UNITED STATES PATENT AND TRADEMARK OFFICE

APPLICATION NO.	FILING DATE	FIRST NAMED INVENTOR	ATTORNEY DOCKET NO.	CONFIRMATION NO.
10/553,048	10/12/2005	Kazuharu Mishimagi	JG-SU-5218/500577320068	2476

Office Action Summary	Application No. 10/553,048	Applicant(s) MISHIMAGI, KAZUHARU	
	Examiner Paul A. Chenevert	Art Unit 3612

DETAILED ACTION

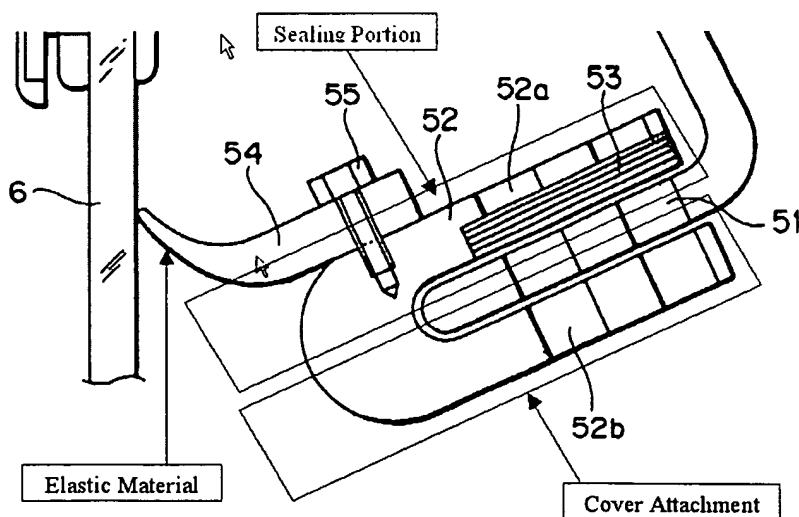
8. Claims 1 & 4 are rejected under 35 U.S.C. 102(b) as being anticipated by Iino.

Iino discloses a vehicle side visor cover, which is attached on a side visor (10), the side visor cover comprising: a cover attachment portion attached on an outer surface of the side visor; a sealing portion whose outer rim is integrally connected with the lower edge of the cover attachment portion; and an elastic material as shown in the detailed Figure 11 below.

In regards to claim 4, the side visor cover is attached to lower outer surface of a horizontal portion of the side visor.
